то	Zac Lovell	DATE	21/10/2025
FROM	Josh Farner	TIME	
PROJECT	New Tasmanian Youth Justice Facility	PROJECT Nº	24.0447
SUBJECT	Response to Council RAI	REF Nº	EA-C02

A Request for Additional Information (RFI) was received from Southern Midlands Council for the proposed Tasmanian Youth Justice Facility (DA2500106) on 30 September 2025.

The additional information concerning to the site Civil design has been provided in Civil Engineering Drawings and a revised Concept Services Report, both dated 21 October 2025. This Engineers Advice provides a summary of the RFI information provided in these documents, and provides further detail where required. It should be noted that the design drawings are for the purpose of concept design for development approval. Further engineering design will be carried out during the detailed design phase to produce the final design and documentation for construction.

TASMANIA, AUSTRALIA 7000 | 466 BRIGHTON RD, PONTVILLE ph 03 6223 8877 STORMWATER LONGITUDINAL SECTIONS 01

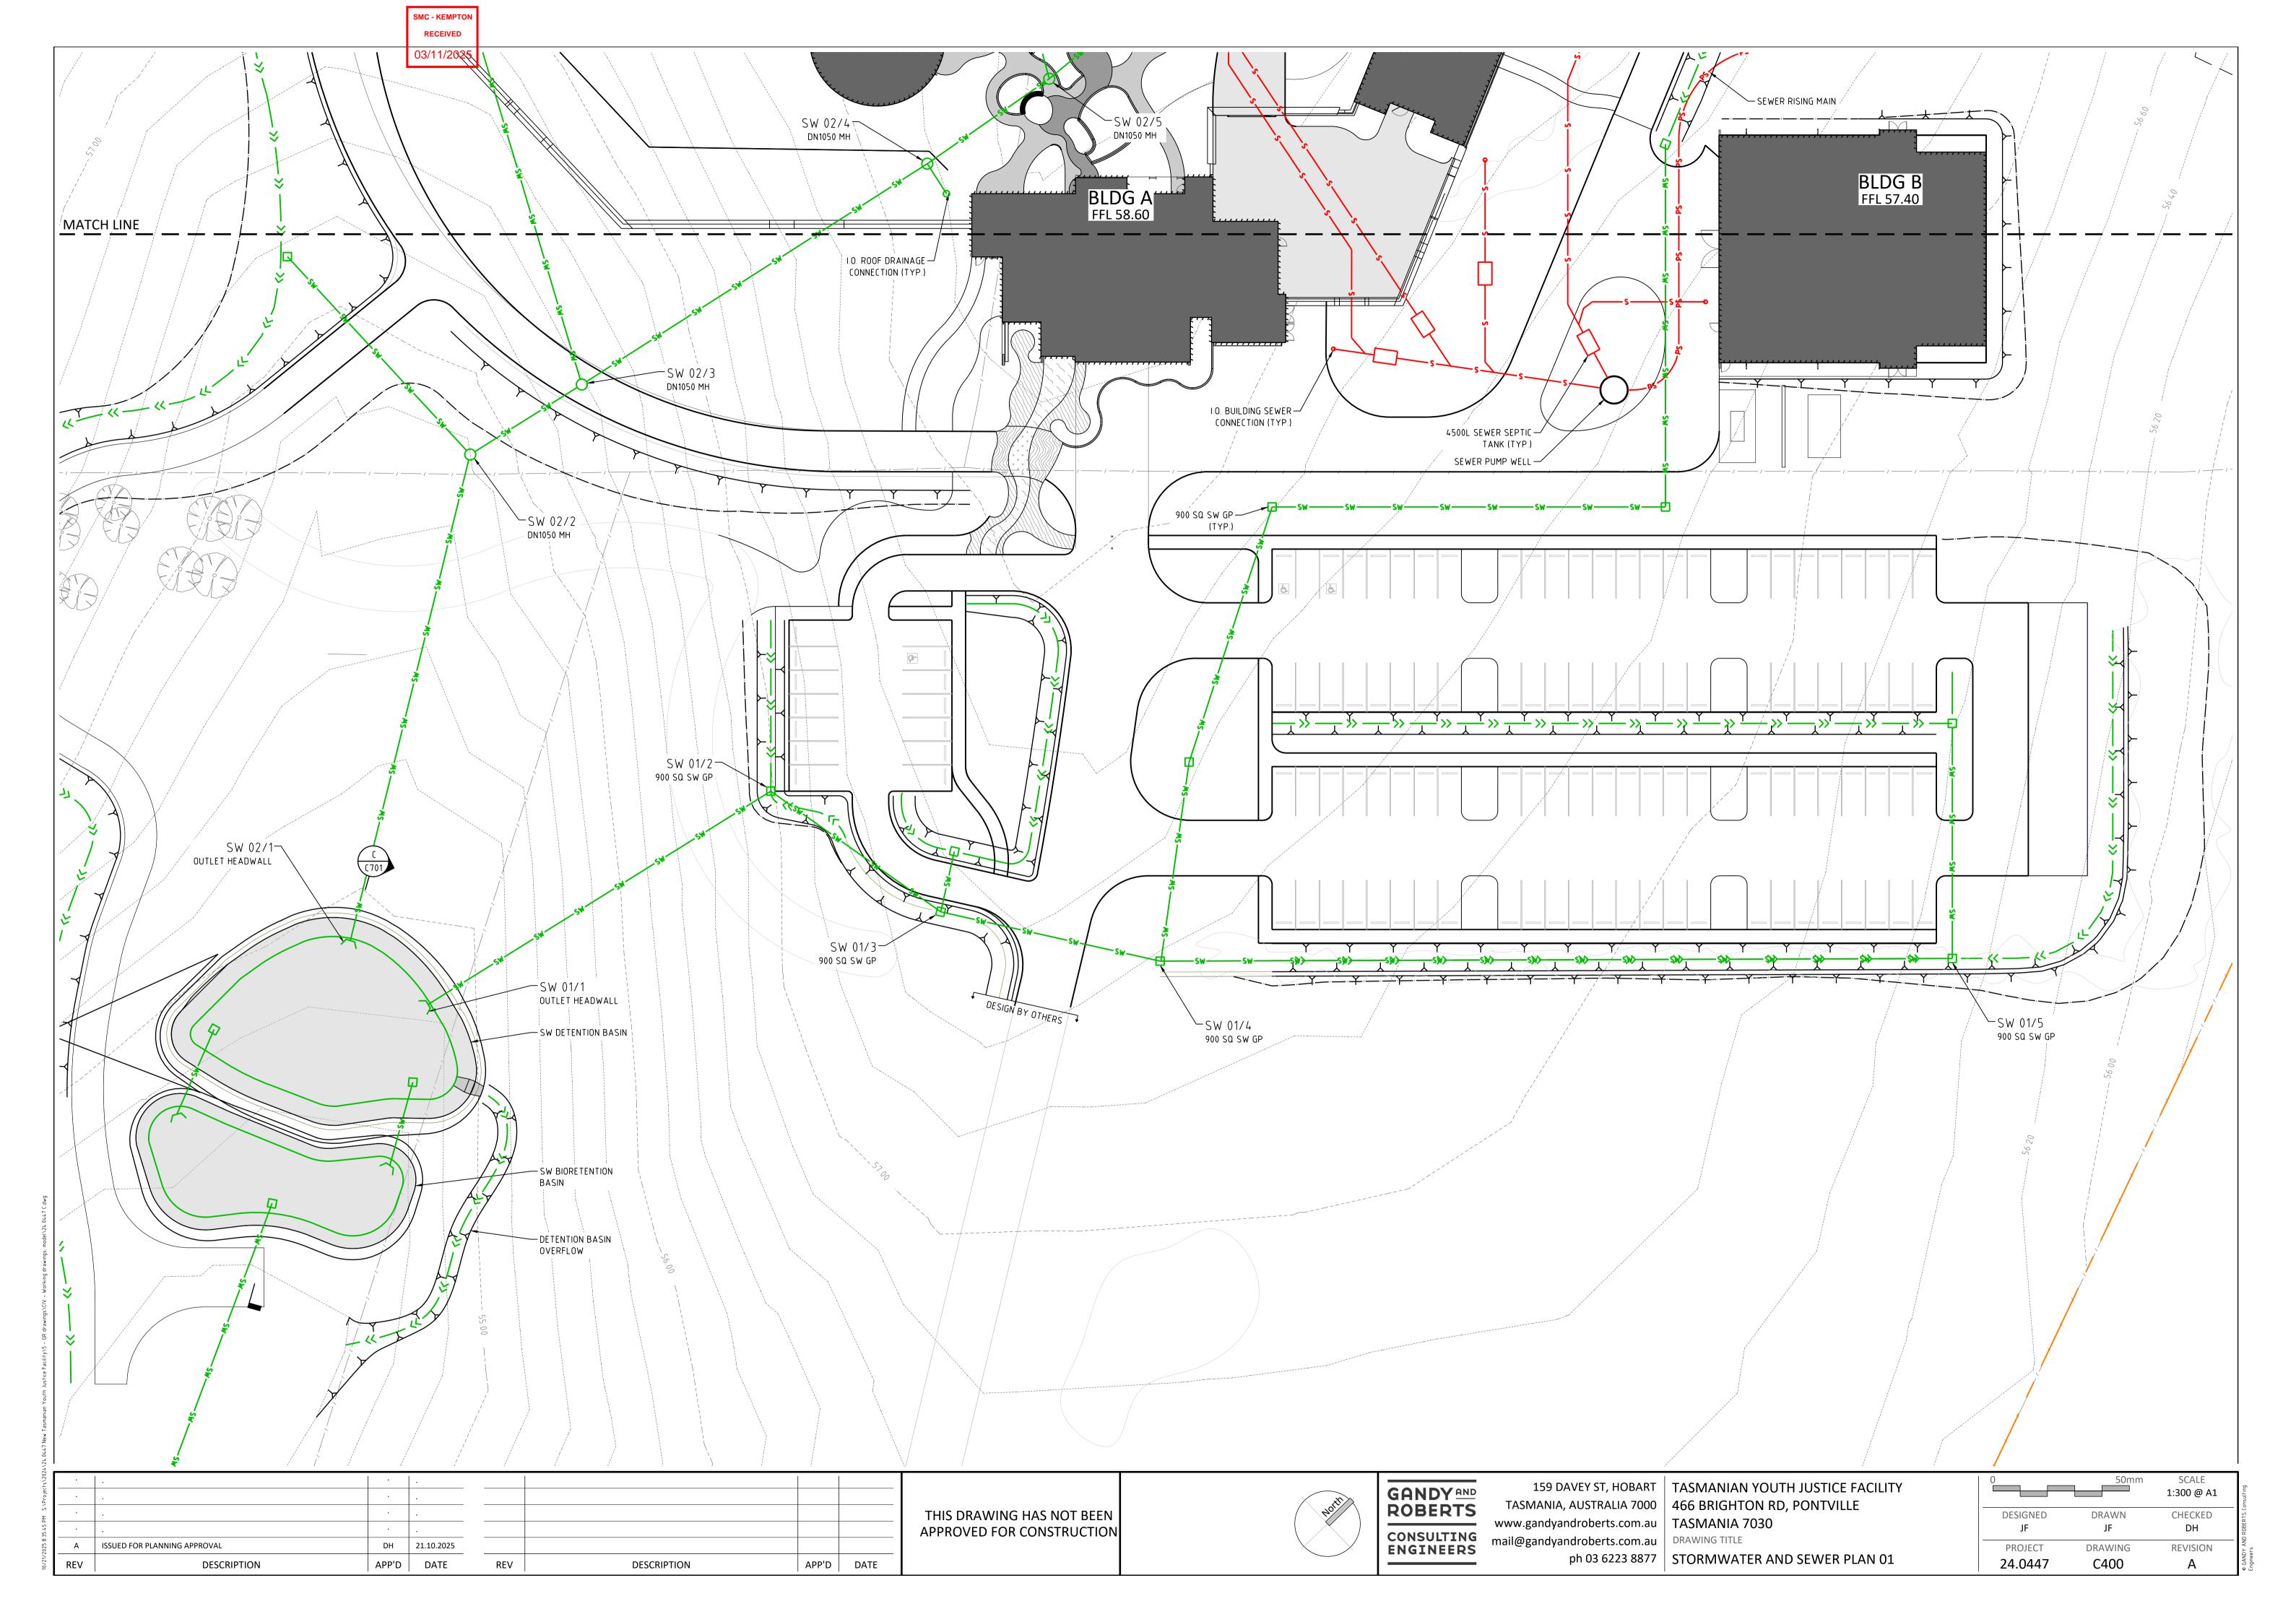
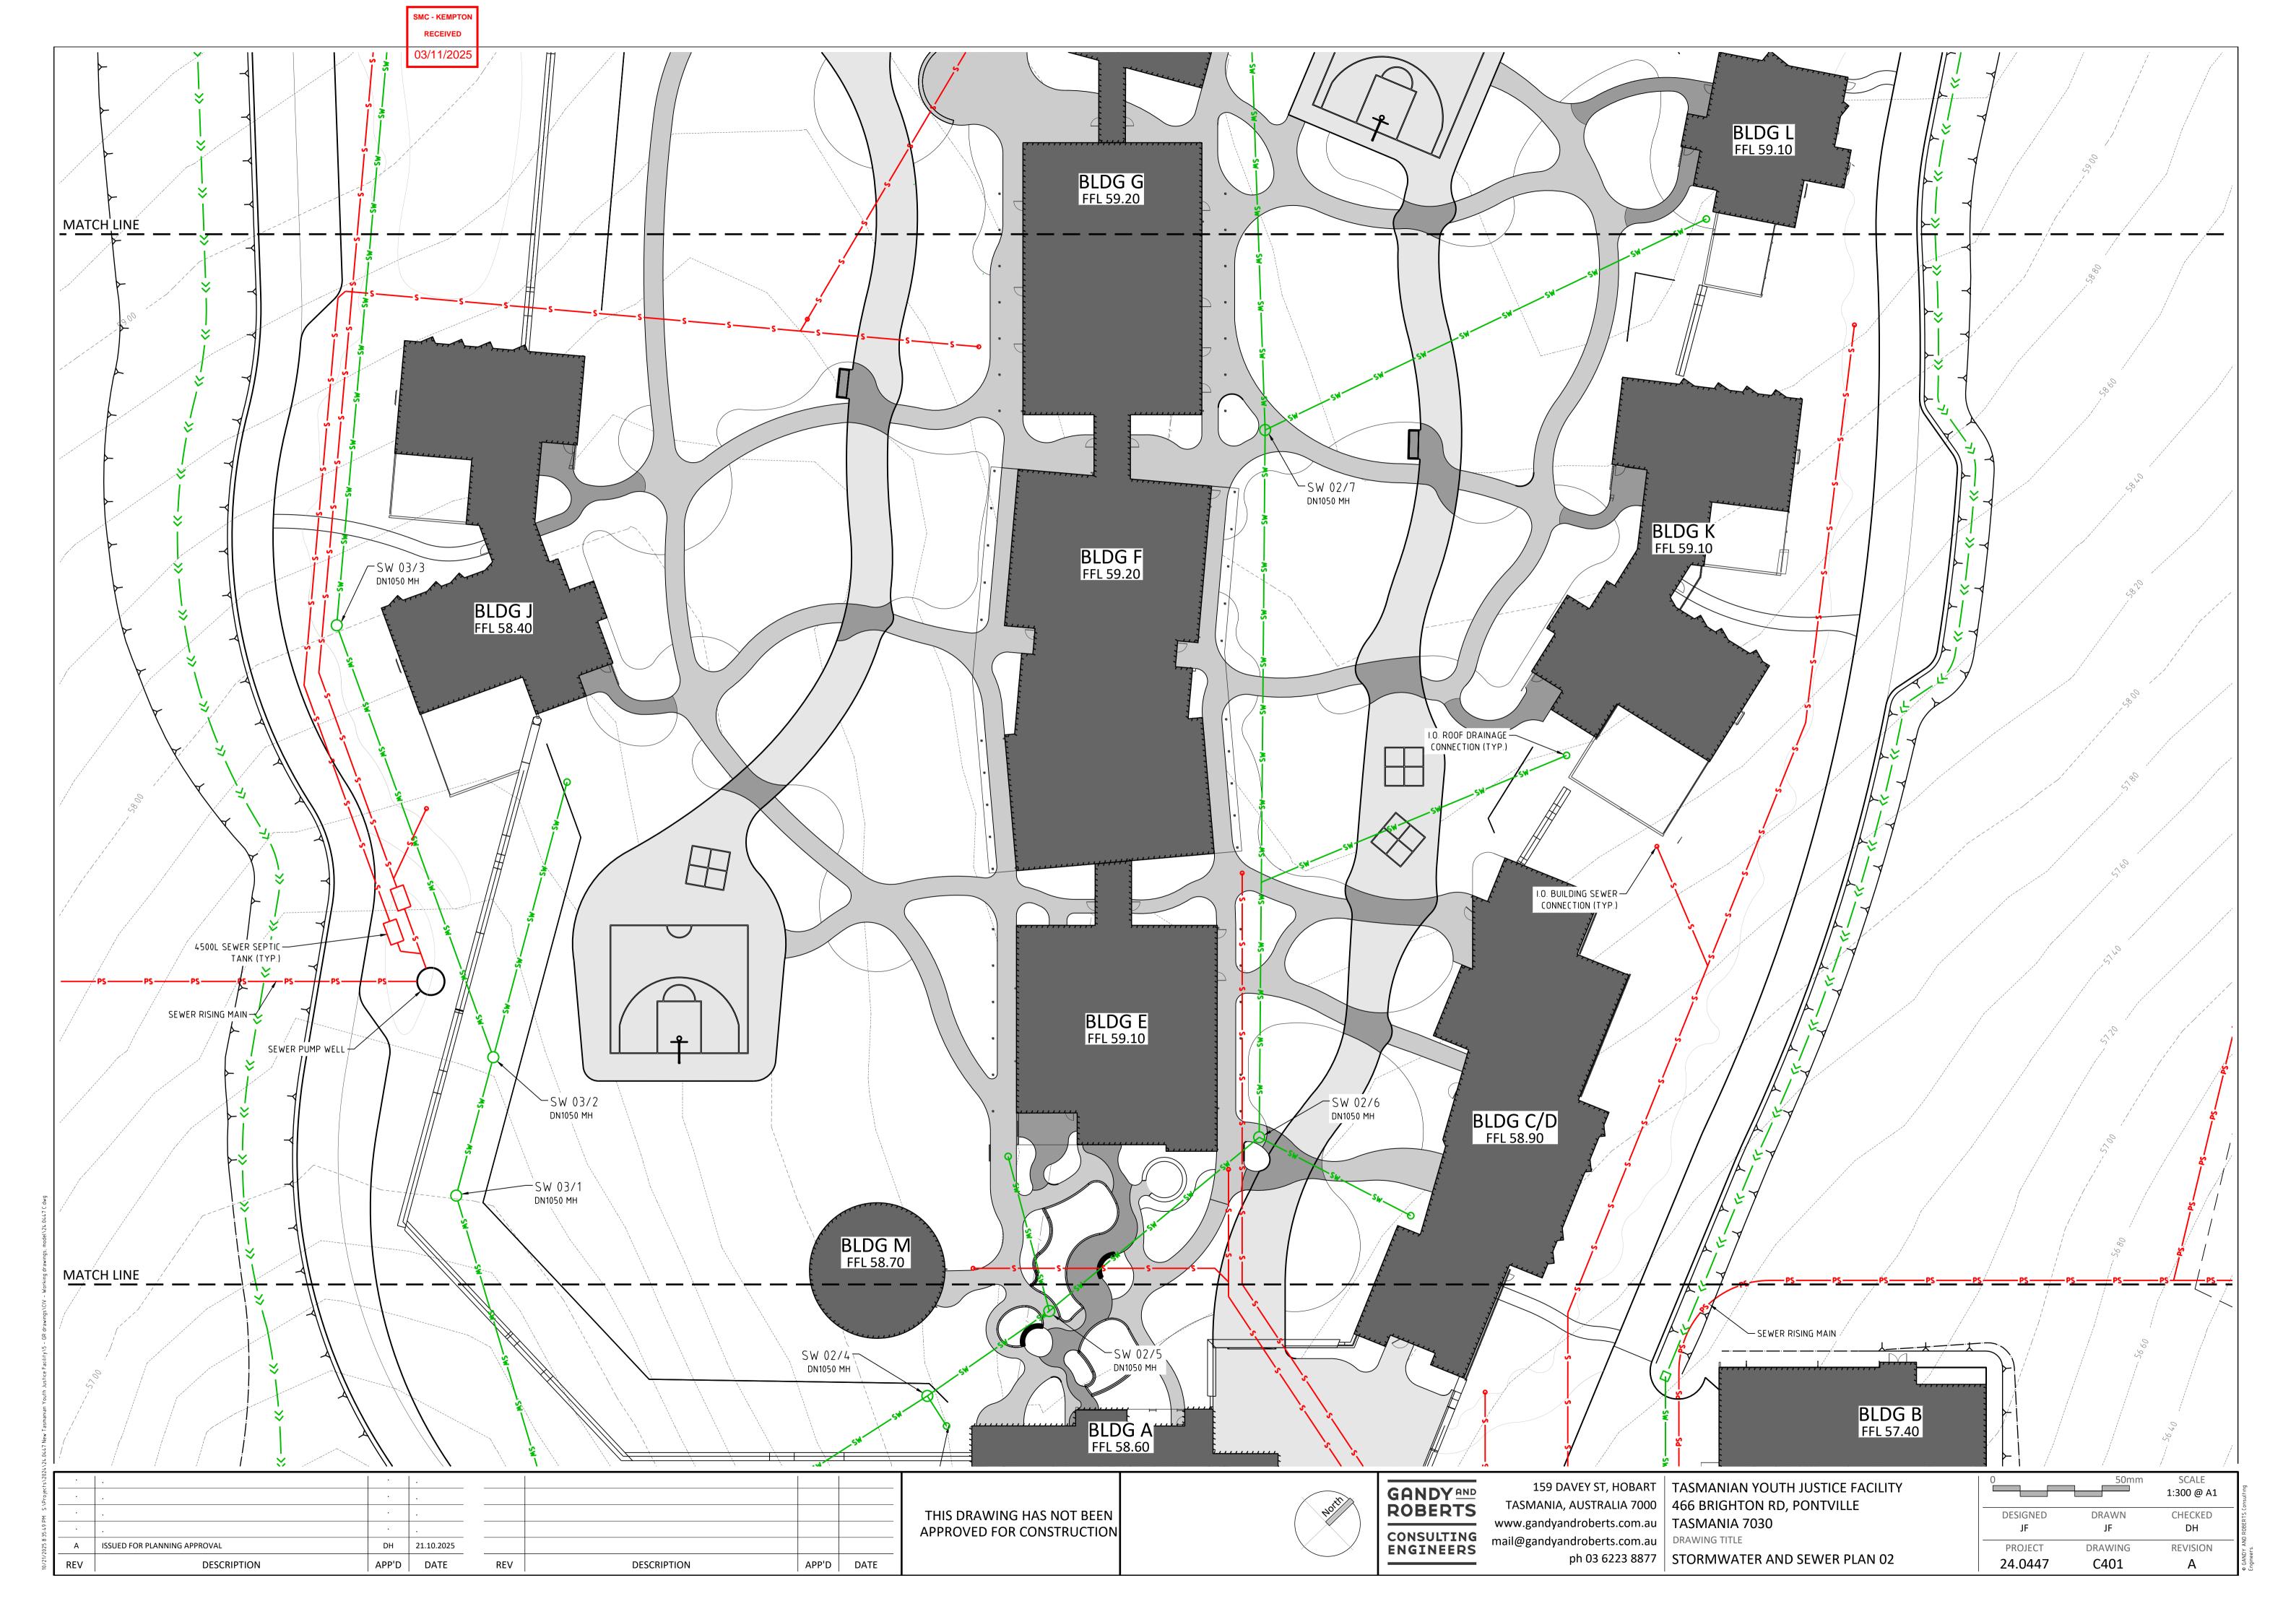
• Provide stormwater long sections for major internal stormwater alignments, sized to convey the 5% AEP storm event.

Concept stormwater design longitudinal sections are provided in drawings C410-412. Detailed hydraulic design of the system to cater for the 5% AEP rainfall runoff shall be undertaken for building approval, once the detailed landscape design is finalised. As noted in the concept services report, on site detention shall be provided to ensure that post development runoff (up to a 5% AEP rainfall event) does not exceed the 5% AEP pre-development runoff.
